# City of Highland

Combined Planning & Zoning Board Agenda  
Highland Area Senior Center – 187 Woodcrest Drive  
November 1, 2023 7:00 P.M.

# MEMORANDUM

**Proposal:** Preliminary and Final Plat

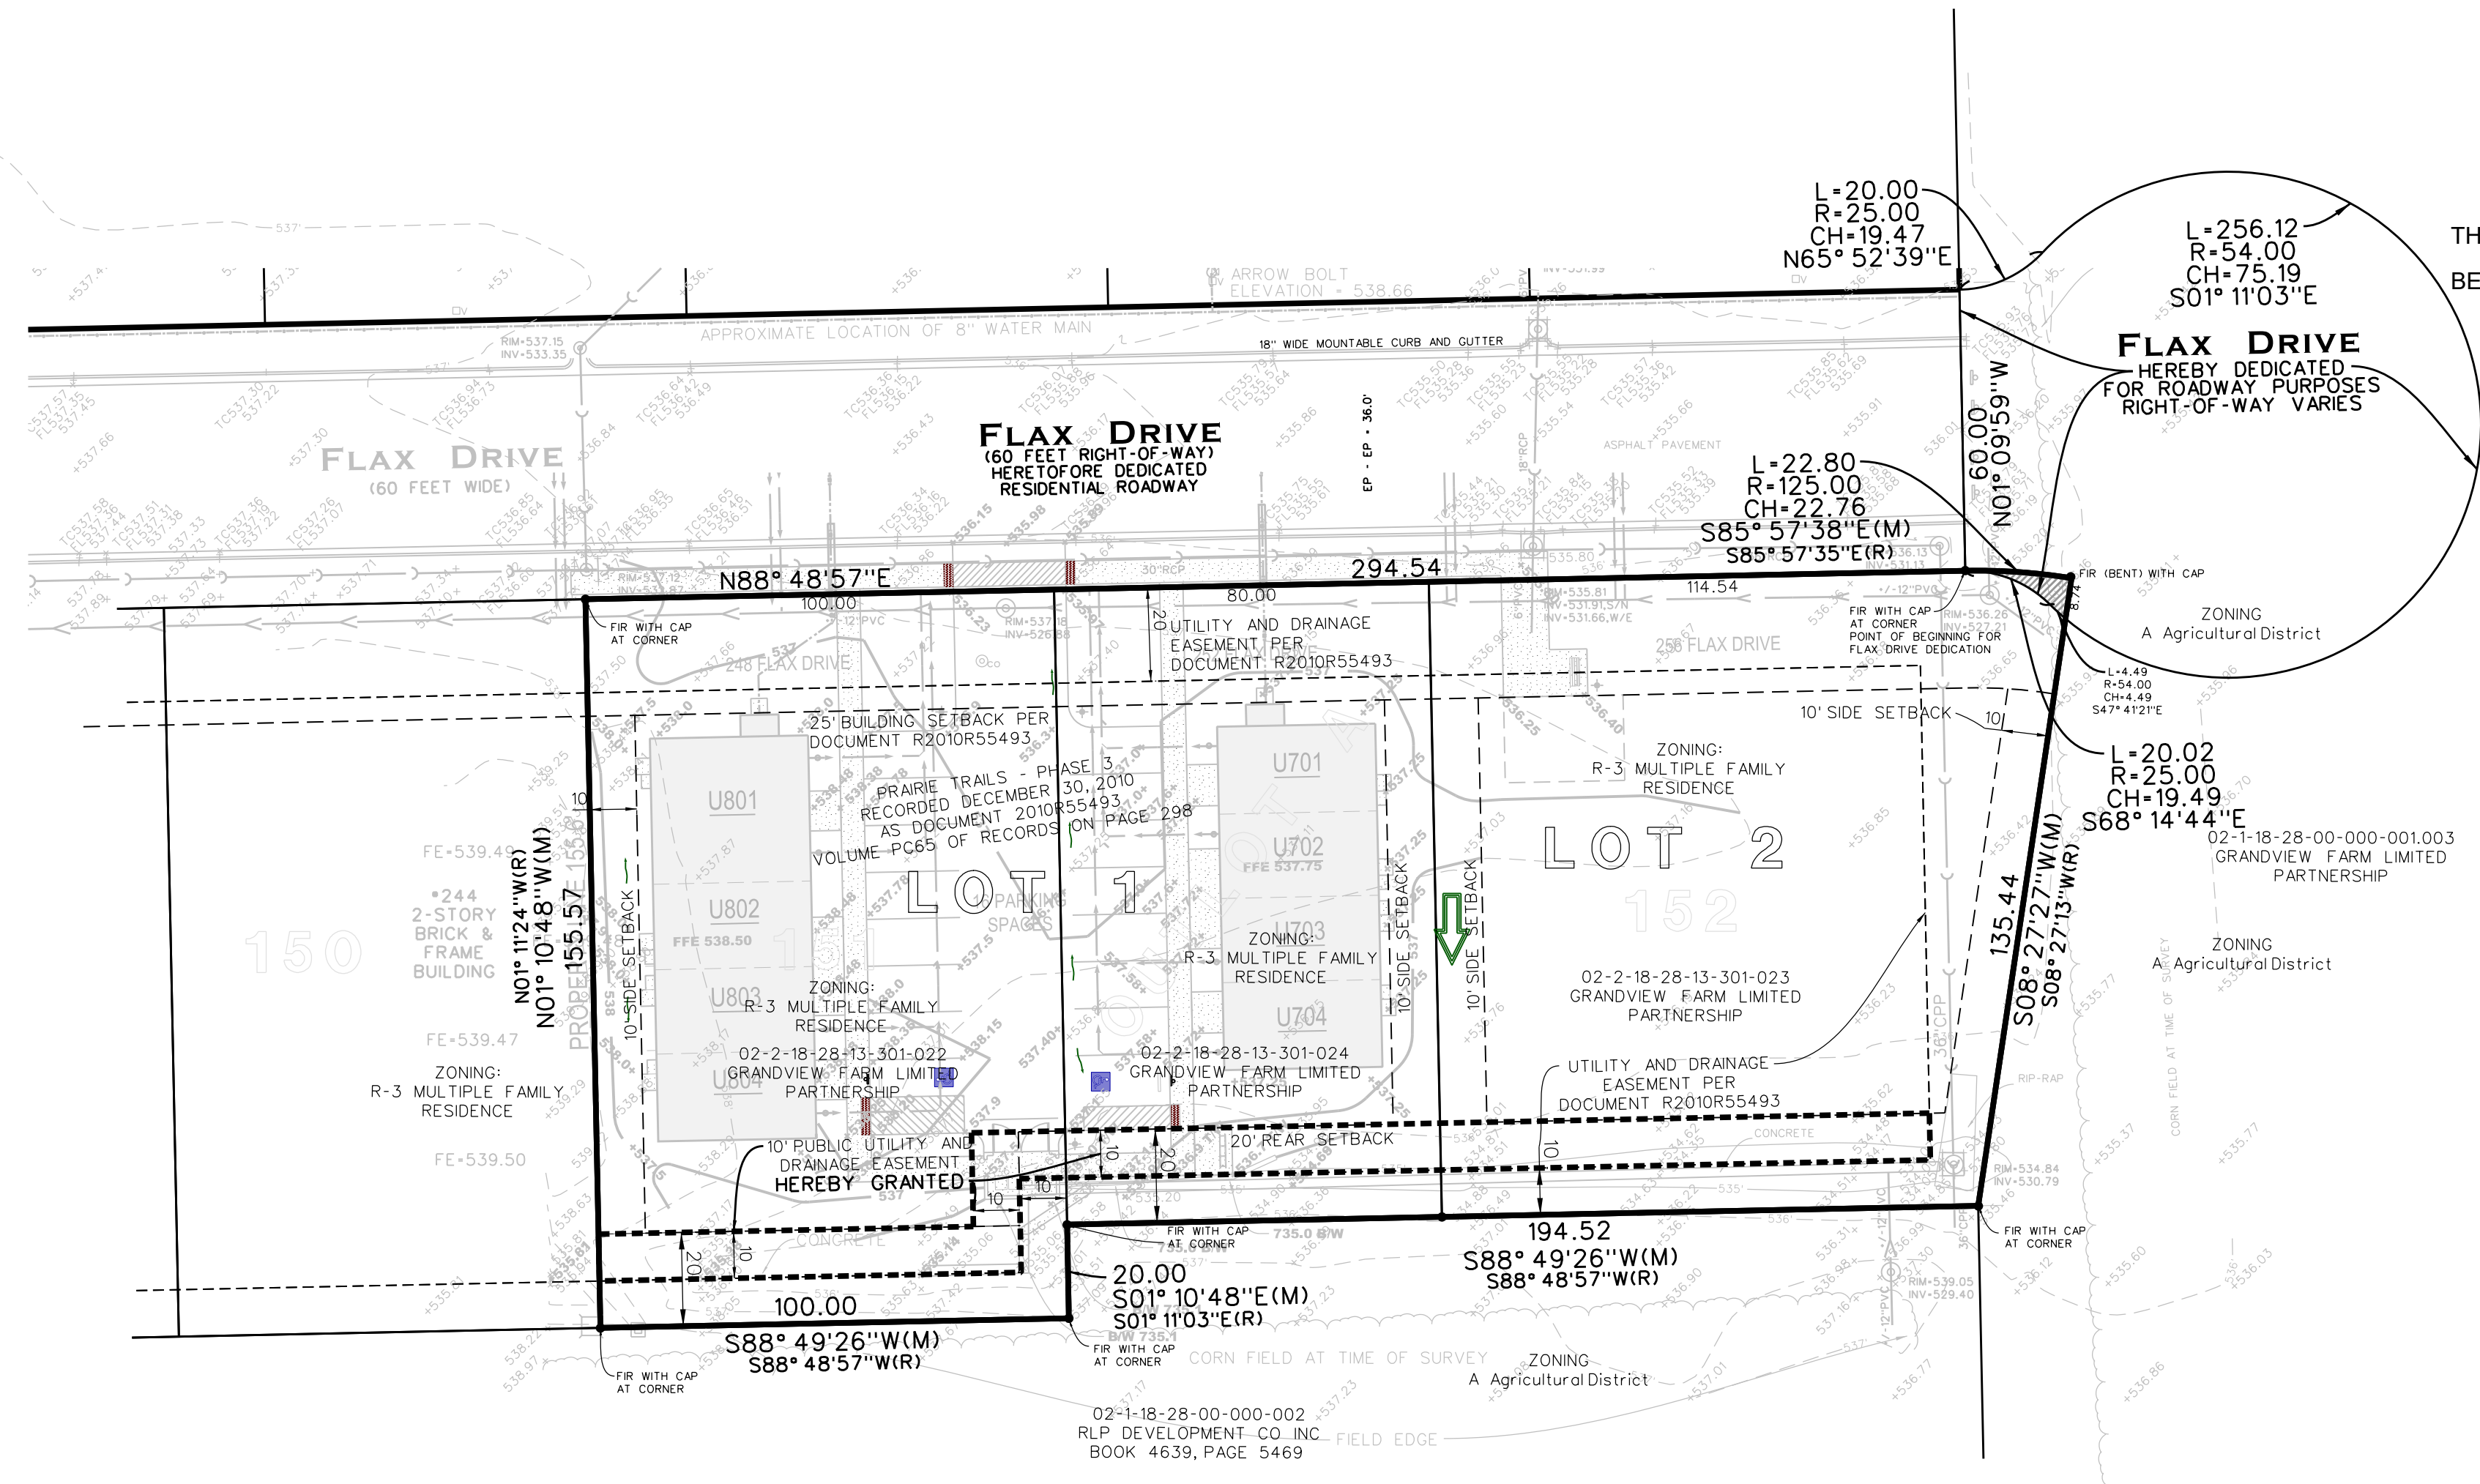
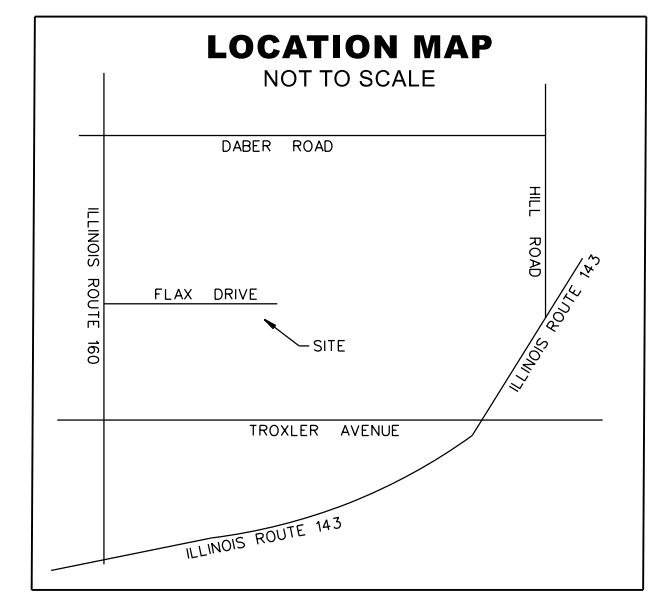
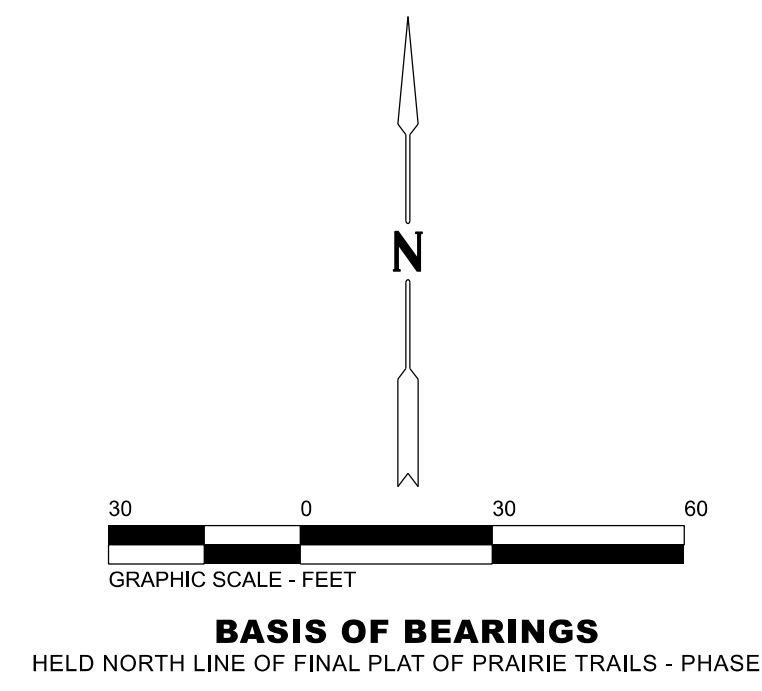
1. The legal description requires an amendment so that the highlighted text matches the highlighted callout.

2. The lot line originally dividing the cul-de-sac from the remainder of Flax Drive and Lot 151 from Outlot A should be shown in gray on the preliminary plat and eliminated completely on the Final Plat.
3. Dimensions of all lot lines are not provided consistently. A dimension is needed for the south property line of Lot 2. The north property line of Lot 1 should be shown as 180' (with the elimination of the old Lot A western property line). A dimension of 80' is needed on the south property line of Lot 1, east of where the lot jogs north.
4. Easements and setbacks along the south property line of Lots 1 and 2 should be shown using the same line. References to a 10' delineation should be removed since both easements and setbacks are required to be 20'.
5. Deed restrictions and/or covenants are required.

In consideration of the information presented herein, it is recommended that the Preliminary Plat be approved with the condition that Plat Review items 1-5 are addressed prior to City Council. It is also recommended that the Final Plat be tabled until the cul-de-sac Improvement Plans are approved.
